ADDENDUM No. 3
FOR
LINK – Multi-Use Development
BID PACKAGE – All Trades

Date of Issue: April 24, 2023

LINK – Addendum #3 Narrative

4/21/23

WALL CONST. @ STAIR
- APPLIED BITUMINOUS DAMPROOFING ON FACE OF CONCRETE/MASONRY WALL
- 1" RIGID INSULATION
- 1" AIR SPACE (FLEXIBLE THICKNESS TO ALIGN BRICK VENEER ACROSS)
- BRICK VENEER (SEE ELEVATIONS FOR EXACT BRICK TYPE)

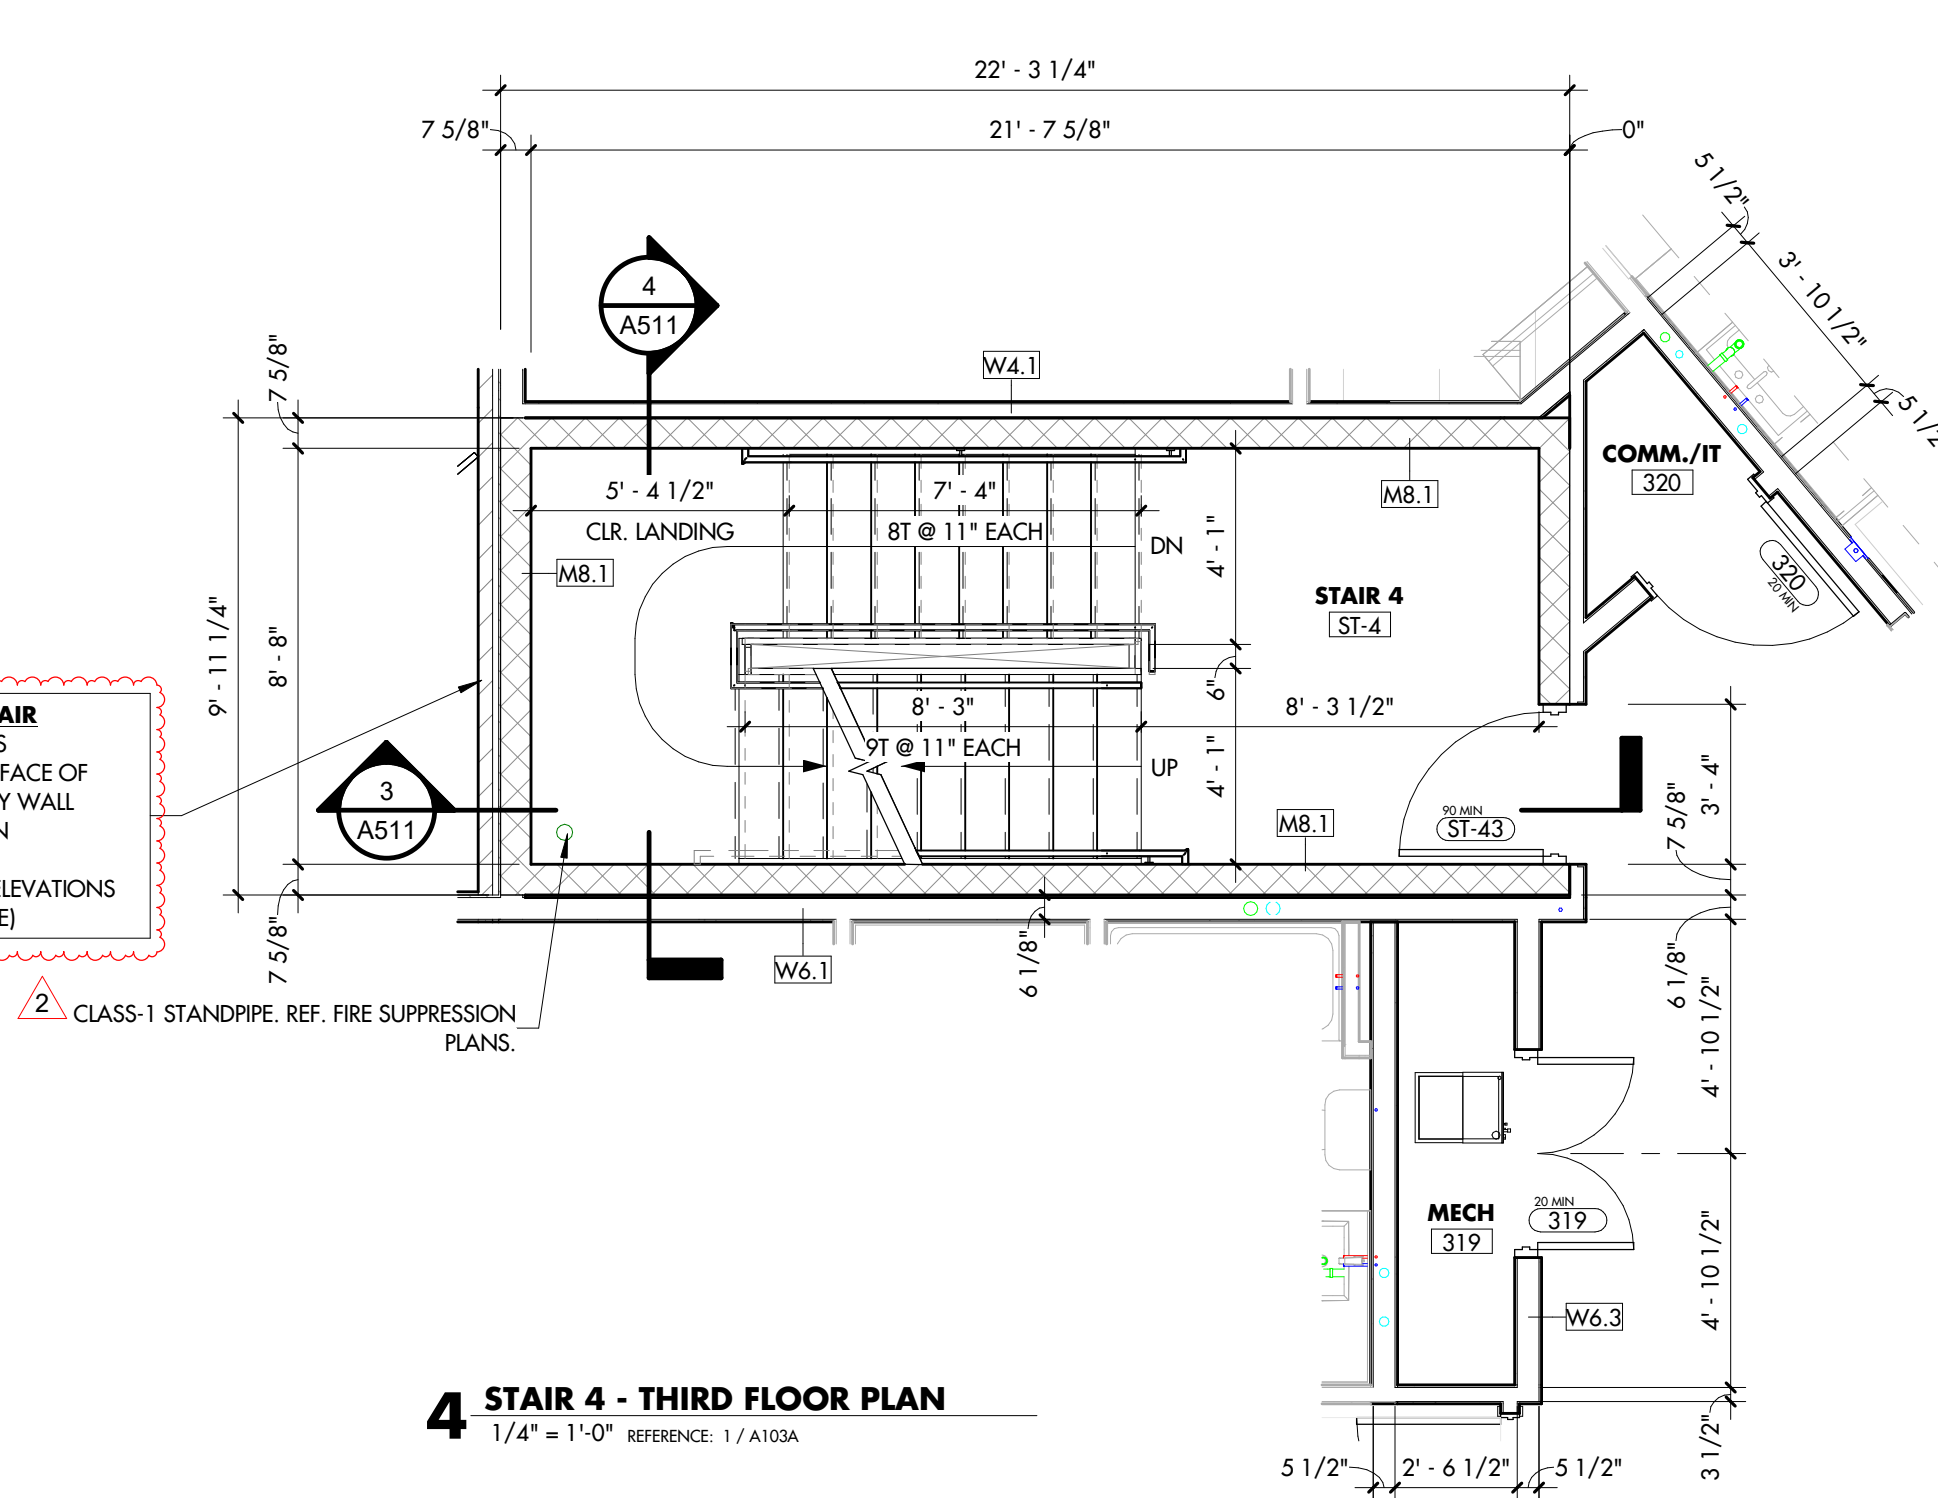
- A504
 - Clarified exterior wall construction at stair.
- A601
 - Revised door finishes.
- A602
 - Revised door finishes.
 - Revised pre-hung unit door heights.

P100

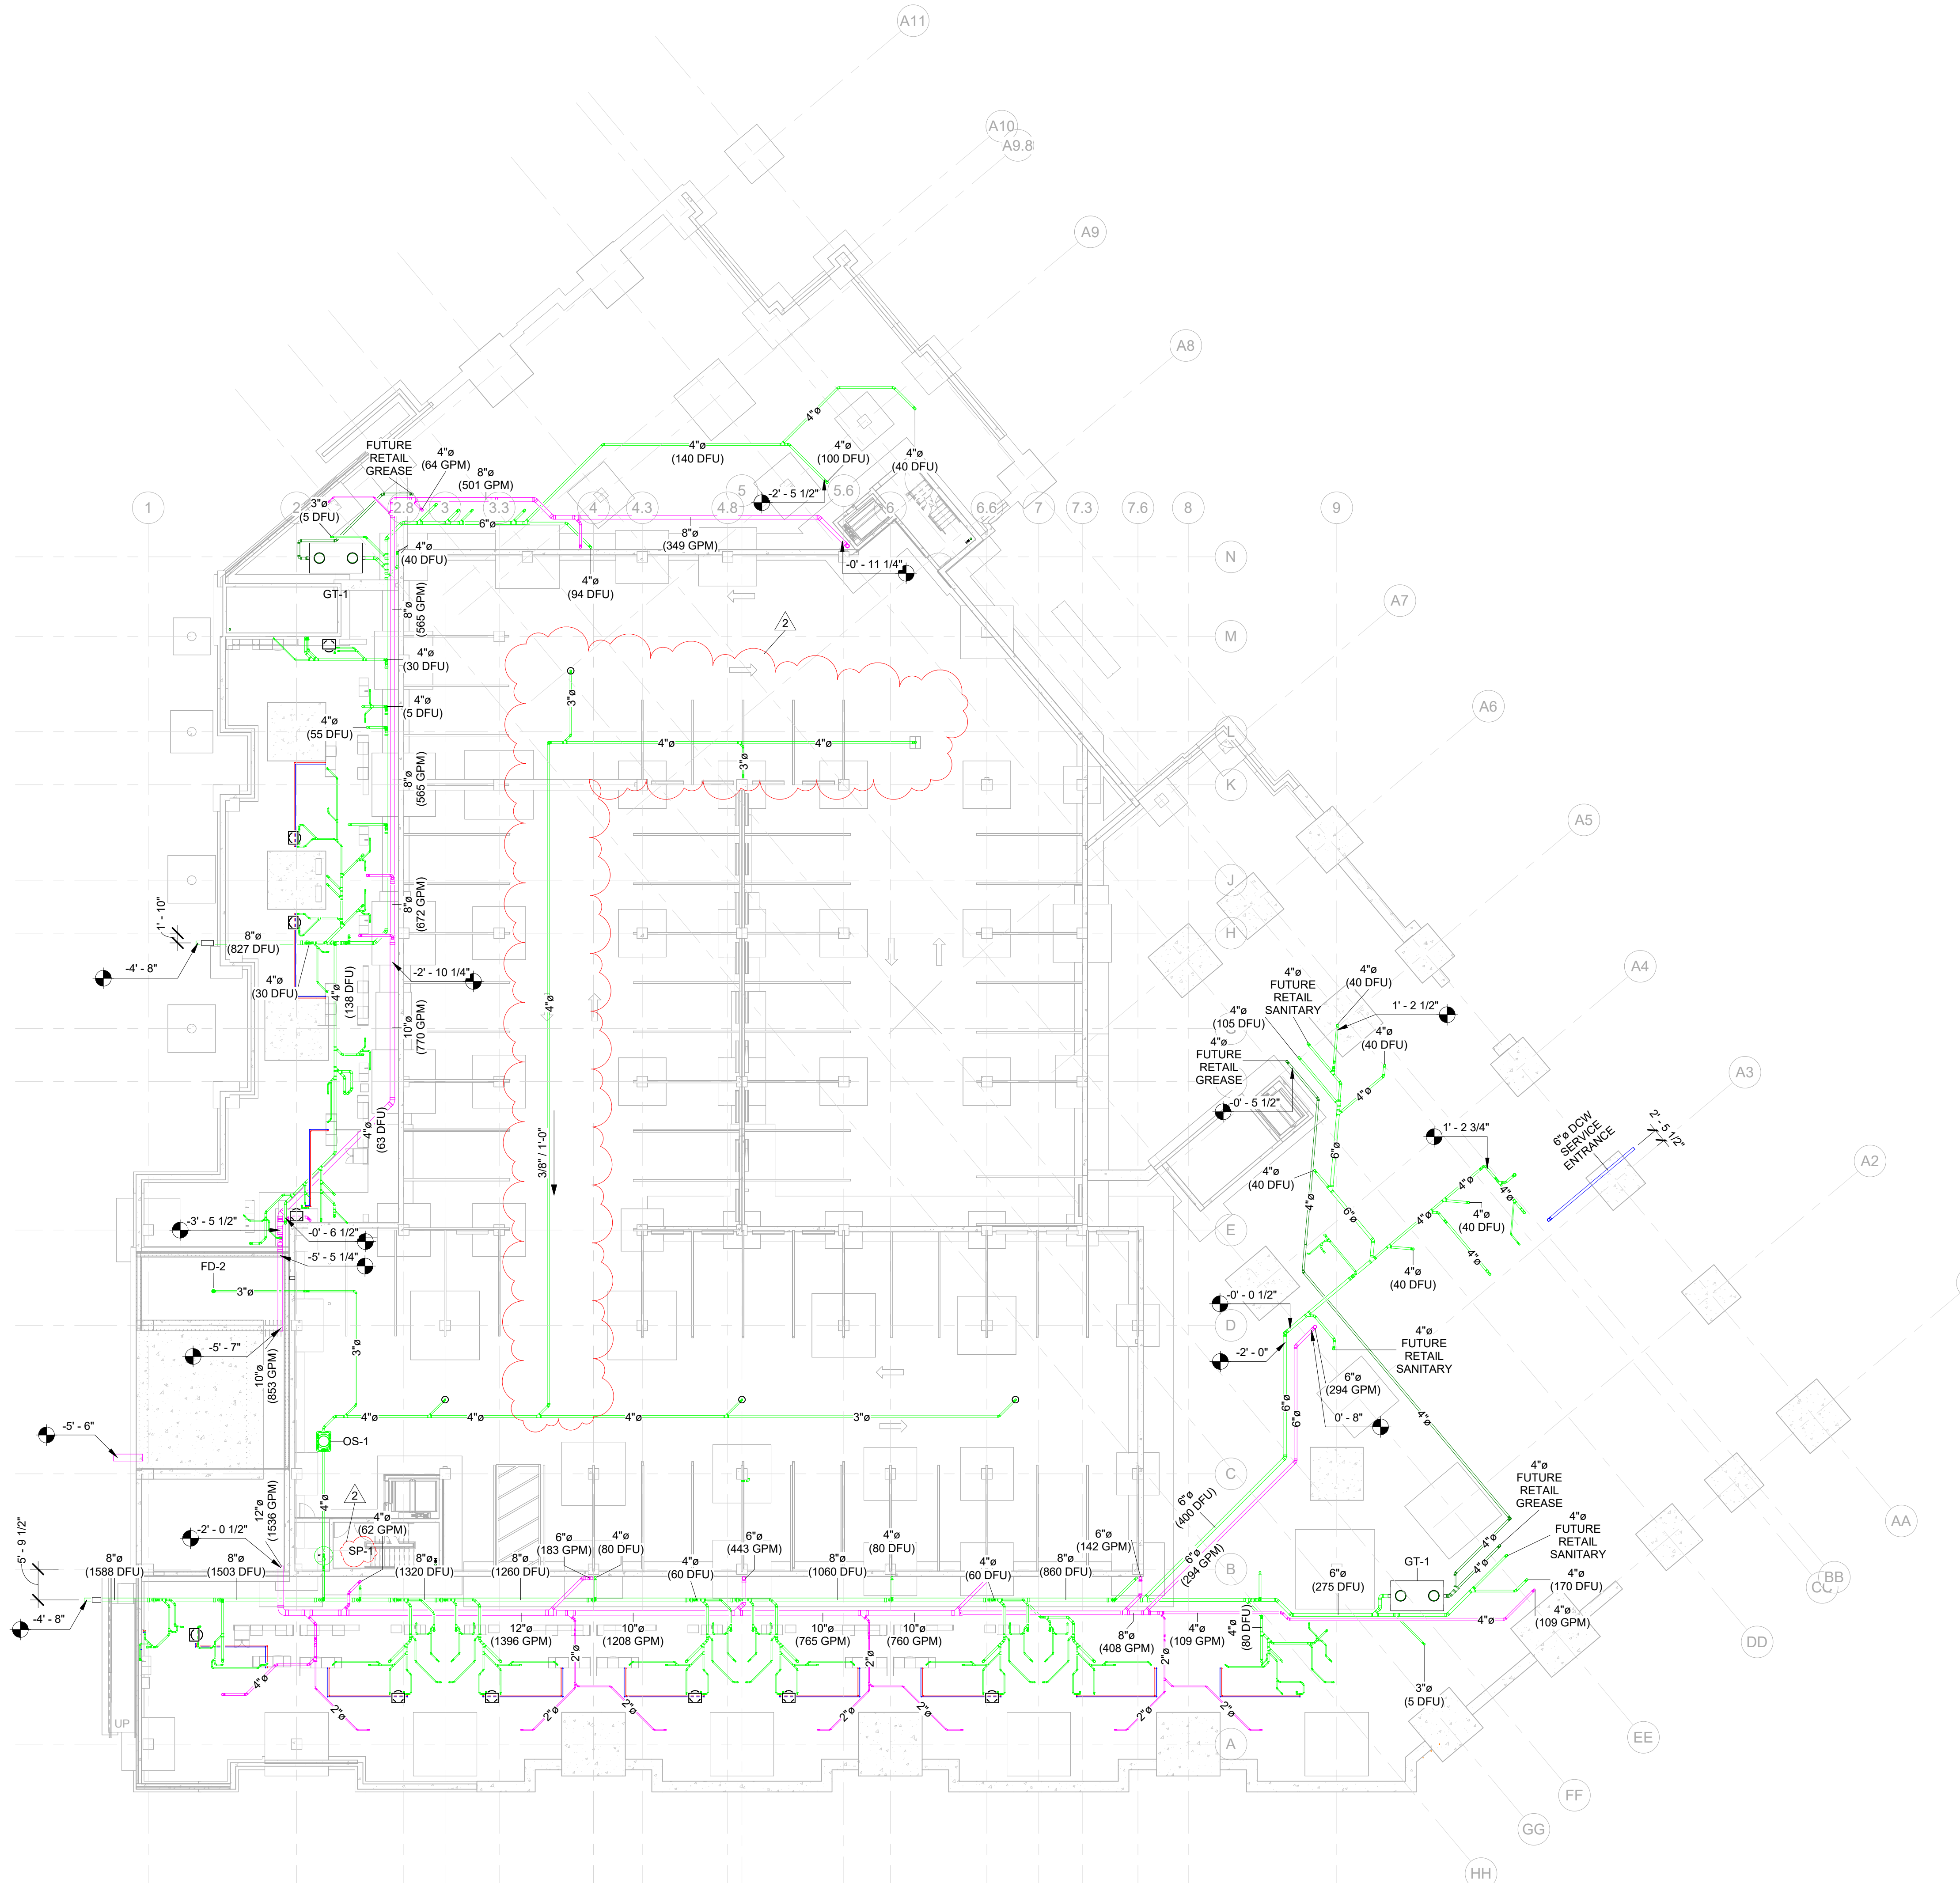
- **Plumbing**
 - P001
 - Revised sheet list.
 - Mop sink added to plumbing fixture schedule.
 - Pfister faucets revised to Delta to match base bid.
 - P100

- Added missing tag to sump pit.
 - Relocated long N/S garage drainage to underslab, allow garage drains at N end to tie in & eliminate ceiling obstructions in garage.

P101

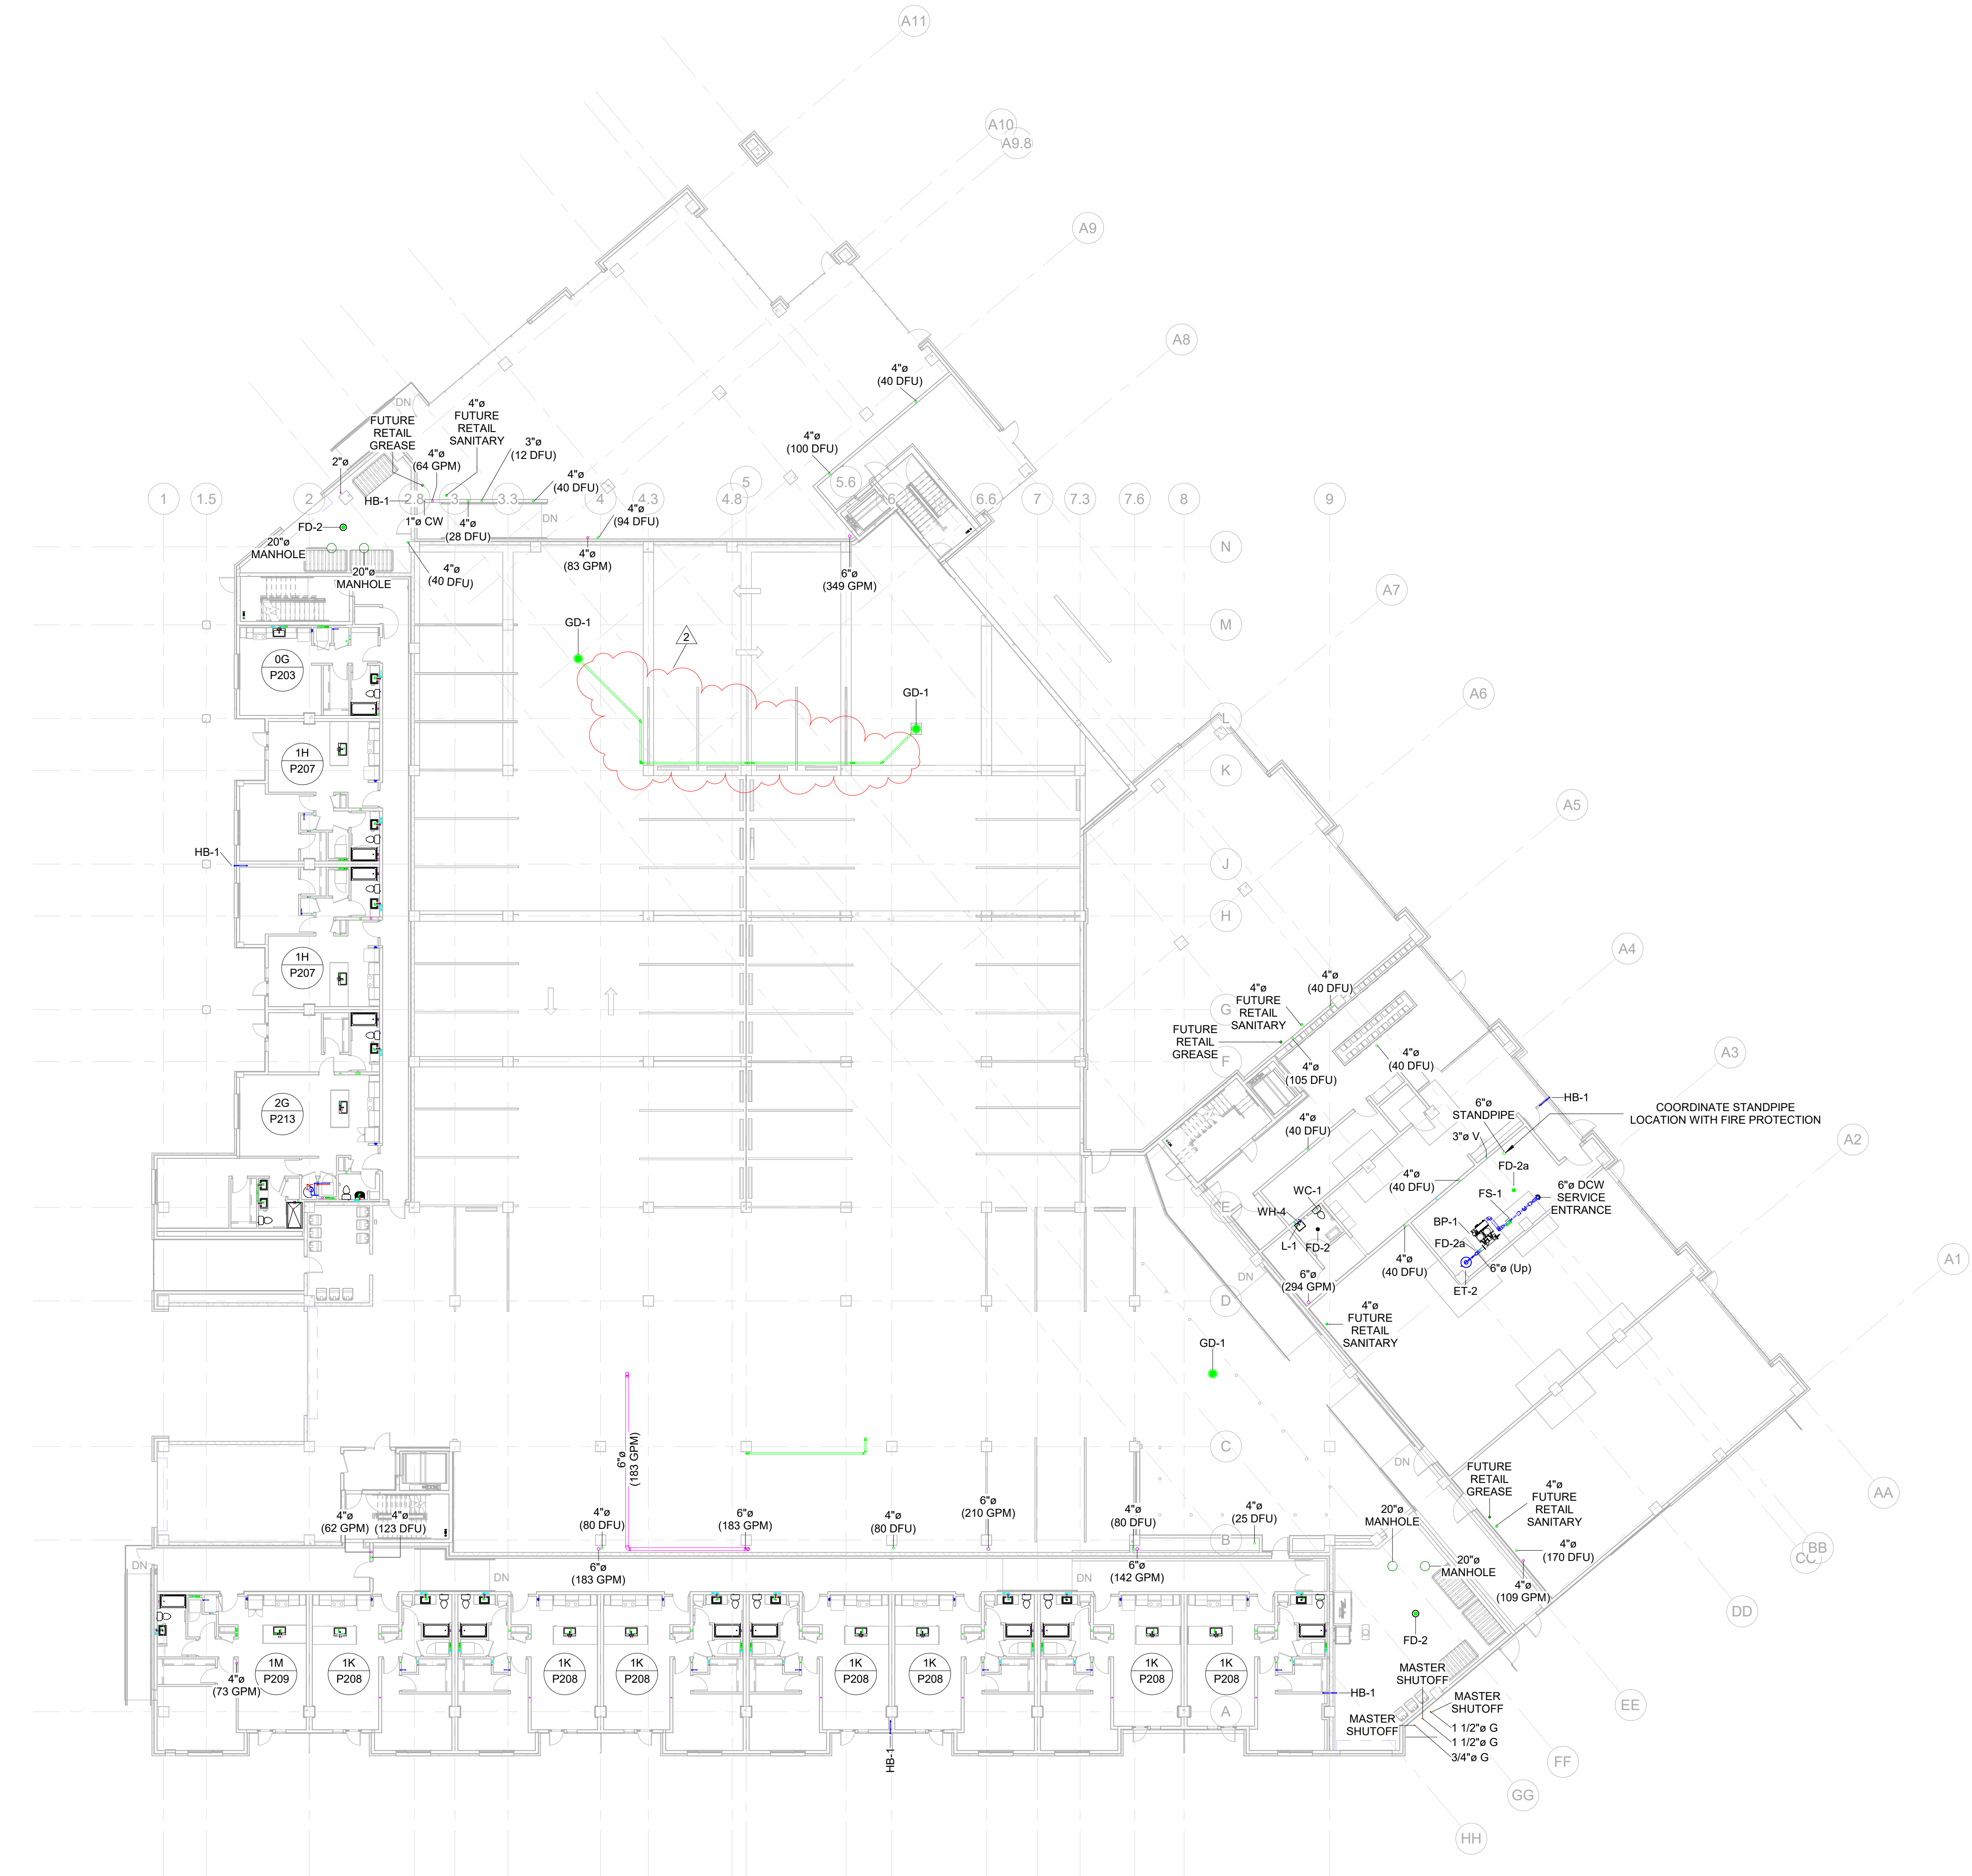
- P100.1
 - Garage drainage stack brought down.
 - P101
 - Revised garage drainage routing to eliminate ceiling obstructions in garage.
 - P101.1
 - Upsized mop sink piping to 3".
